**Subject: MHI's Amended Response to US-APWR DCD RAI No. 897-6280 Revision 3
(SRP 05-04 Branch Technical Position)**

Amended Response to Request for Additional Information
No. 897-6280 Revision 3

RAI NO.: NO. 897-6280 REVISION 3
SRP SECTION: 05-04 BRANCH TECHNICAL POSITION
APPLICATION SECTION: 5.4.7
DATE OF RAI ISSUE: 01/30/2012

QUESTION NO.: 05-04 Branch Technical Position-1

Figure 1 RCS Water Level and Water Level Alarm during the Mid-loop Operation

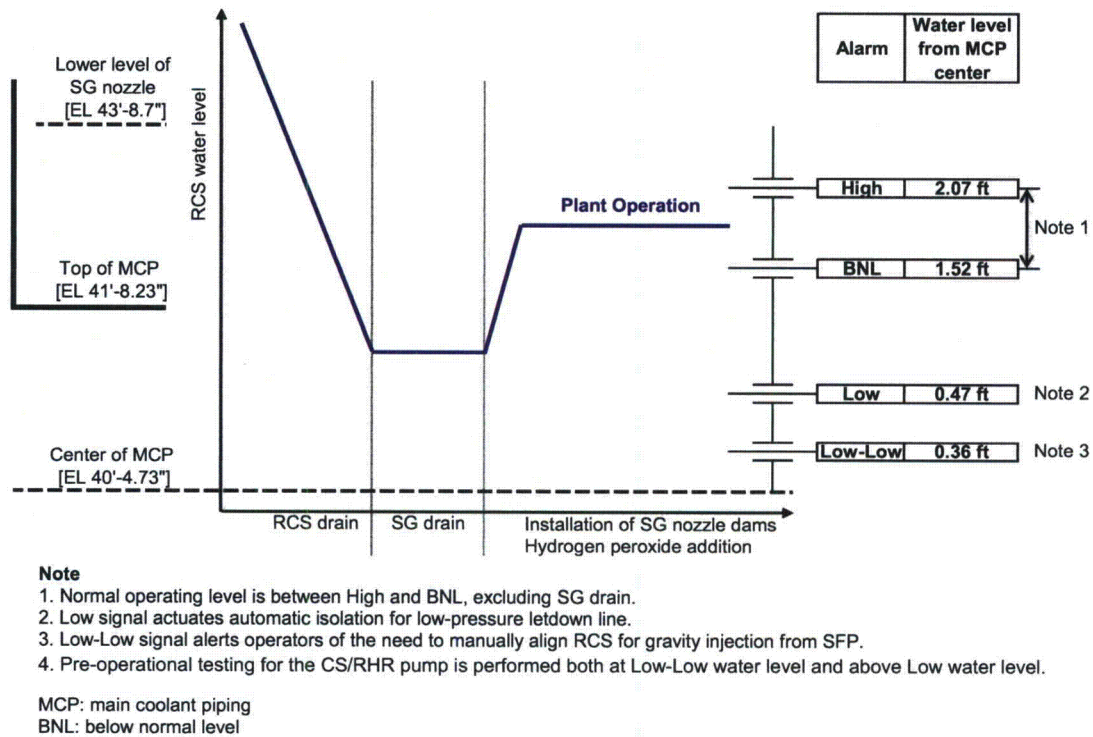
In DCD Section 5.4.7.2.3.6, "Mid-loop and Drain Down Operations" the RCS water level should be maintained higher than 0.33 feet above the loop center with an RHR flow of 1,550 to 2650 gpm. The staff has the following questions:

1. Is the 0.33 feet above the loop center the minimum value including uncertainties?
2. What controls or systems are in place to ensure the minimum mid-loop level is not violated?
3. What tests and/or analyses, at the most limiting RHR flow rate and mid-loop water level, have been performed to ensure that air entrainment and potential vortexing do not challenge the RHR pump safety functions? Describe how the tests and/or analyses are applicable to the US-APWR RHR inlet design.

Enclosed is the amended response to Question 05-04 Branch Technical Position-1 that is contained within Enclosure 1. This response revises Footnote 4 of Figure 1 in the previous response transmitted in Reference 2 to be consistent with Reference 3.

1. The 0.33 feet above the loop center is the minimum analytical value without any intrinsic uncertainty. This value is the basis for the refueling operation and the alarms for the RCS water level. However, the Low-Low water level alarm is set to 0.36 feet above the center level of Main Coolant Pipe (MCP) to account for the instrument uncertainty (.03 feet). (Please see Figure 1)
